**REPORT OF THE STANDING COMMITTEE OF EXPERTS
ON FAILURE OF EHV TRANSMISSION LINE TOWERS
(OCTOBER 2016 – MARCH 2018)**

भारत सरकार
Government of India
केन्द्रीय विद्युत प्राधिकरण
Central Electricity Authority
विद्युत मंत्रालय
Ministry of Power
नई दिल्ली
New Delhi

2. 400kV D/C Silchar- Purba Kanchan Bari Transmission Line failed on 02.04.2017 [Location Nos. 124 - 128 and 137-139]

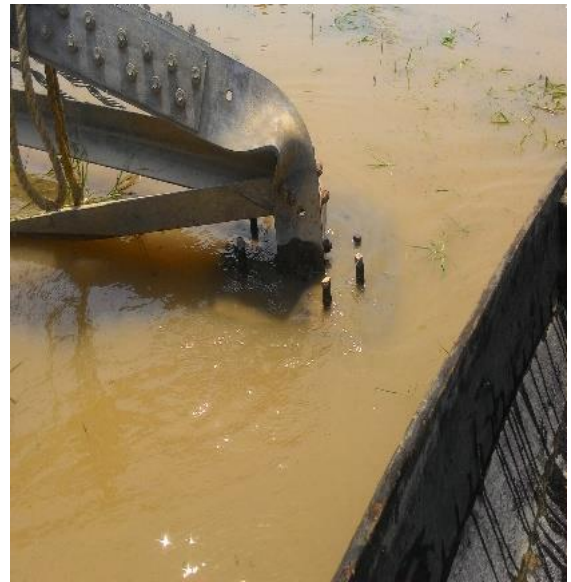
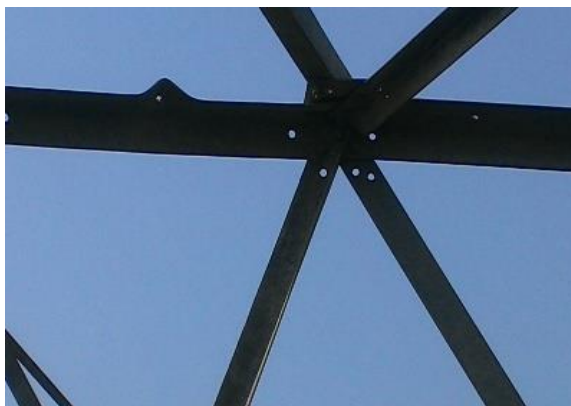
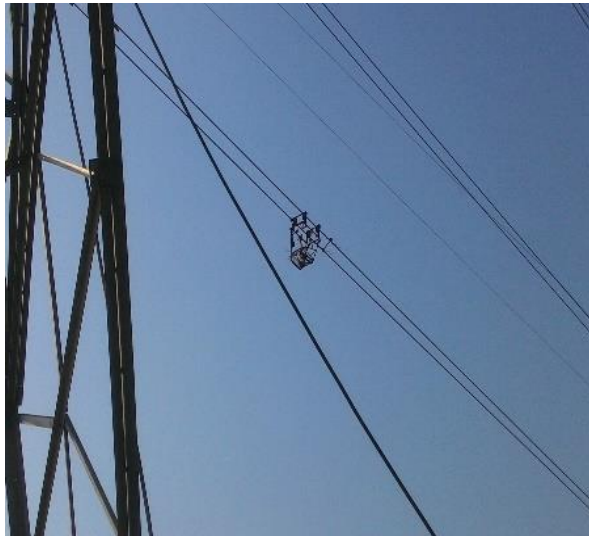
- a. **Tower at location no. 124(DA+0)** was located in plain terrain and completely collapsed to the ground from the stub level in transverse direction. All the 4 stubs got damaged. Three of the chimneys were broken. Coping of the chimneys was not done & Steel reinforcement got exposed in the chimneys. The tower was in water logged area and foundations of the tower

- b. **Tower at location no. 125 (DA+0)** was completely collapsed on ground to the left side in transverse direction when observed facing P K Bari. Foundations of the tower were partially submerged in water. Tack welding of bolts and nut was not done. Tower legs had sheared from the 2nd panel level. The stubs were bent. ACD was not provided. Coping of chimneys was not done and steel reinforcement was protruding from them. One foundation chimney had cracked. As reported that the location was used to be water logged during rains.

- c. **Tower at location no. 126 (DA+0)** was completely collapsed on ground to the left side when observed facing P K Bari. All the four legs were submerged in water. The tower got bent from 2nd panel level and had fallen in transverse direction to the line. Tack welding of bolt & nuts was not done. Cover plate was not provided in one of the joint in all the four legs. The two stubs were bent and the remaining two were intact. Few numbers of bolts were missing in the leg joints. The stubs got rusted due to water logging.

- d. **Tower location No. 127(DD+6)** was in water logging area. All the cross arms of one side of the tower got damaged.
- e. **Tower location No. 128 (DD+9)** was slightly bent above 1st panel level. The tower was in water logging area.

- f. **Tower location no. 137 (DA+0)** fell in the transverse direction. All the stubs of tower were bent and Two chimneys were broken. Many bolts were missing in the joints of leg members. ACD was not available. Extra holes in the main leg members were not plugged. One of the stub was sheared. Coping of the chimneys was not done properly.

- g. **Tower at location no. 138 (DA+0)** had collapsed from the stub level towards left side when observed facing P K Bari. Unplugged holes were present in the members of the tower which were. Coping of the chimneys were not done. Two stubs were bent & other two were intact. Few numbers of bolts in the joints of bracings and leg members were missing. Anti-climbing device was not provided. The area surrounding the failed tower was water logged.

- h. **Tower at location no. 139 (DD+0)** was in erect position with members above bottom cross arm level twisted and bent towards right side in transverse direction when observed facing P K Bari. Members above first section got buckled & the foundations were intact. Coping of chimneys was not done. Steel reinforcement was protruding from three of the chimneys. A number of holes in tower members were not plugged. Few numbers of bolts were missing in

The erection deficiencies such as missing cover plates, missing bolts in butt joints of leg member, unplugged holes, rusted stubs due to water logging etc. might have resulted in reduced strength of tower and combined with localized wind storm might have caused the failure of towers. It was observed that the line was charged without taking proper caution as

a trolley which was used during erection was still hanging on the live wires near tower location No. 139(DD+0).

The committee recommended that intensive care should be taken during Erection and installation of towers (Slope correctness, filling unplugged holes, tightening of Bolts, Tack welding, straightness of tower members etc). In theft prone areas, frequency of patrolling should be increased and assistance of local people should be taken to avoid failure of towers.

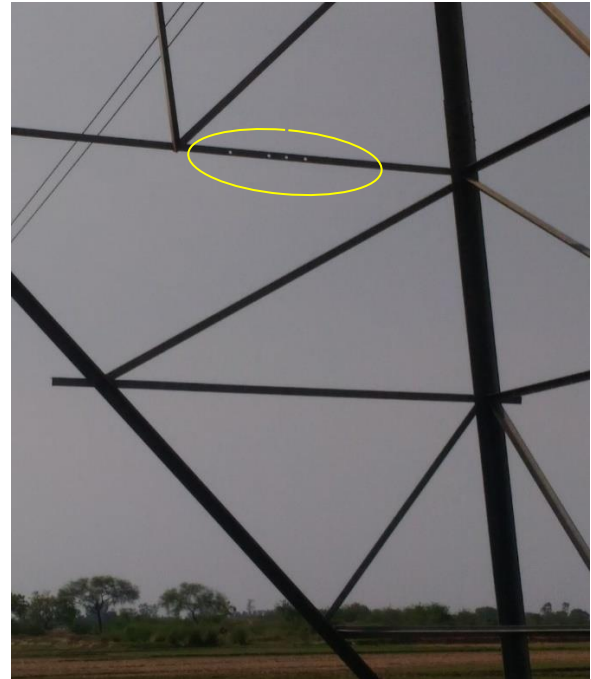
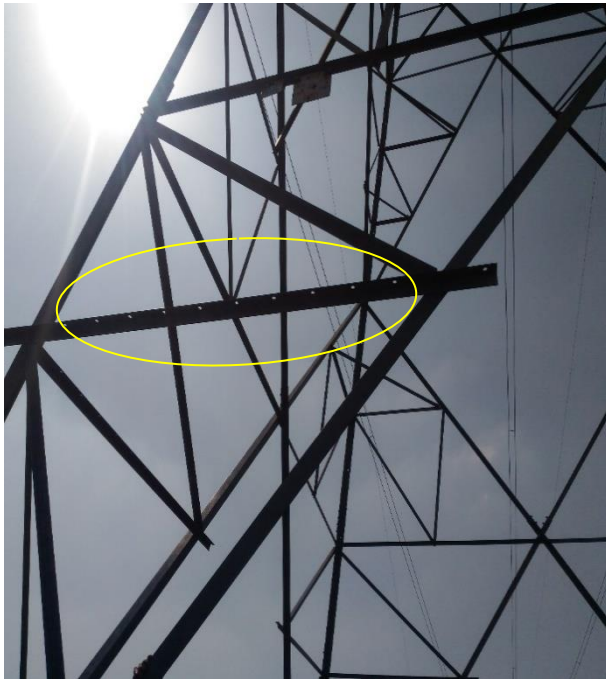
- a. **Tower at location no. 929 (A+3)** was collapsed above extension portion from the first panel in the transverse direction. The foundations of tower were not visible due to waterlogging and presence of grass around the base. Hence, the extent of damage to the foundations could not be ascertained. The failed tower was designed as per IS 802-1977 and was not strengthened by providing hip-bracing.

- b. **Tower at Loc. no. 930 (A+0)** One of the earth wire peak (left side) when seen from loc. 929, was damaged. However, rest of the tower was intact and no other damages were observed to any other members/stubs. Anti-climbing device was missing allegedly due to theft. PGCIL Officials informed that theft was frequent in the area. Holes in few members were left unplugged.

In view of this it was emphasized that the PGCIL, which are facing repeated failure of lines due to high wind speed incident need to perform reliability analysis of existing towers and for new transmission lines thorough study and deep analysis of wind speed data is needed at the initial design stage itself to avoid the failure cases in more realistic manner.
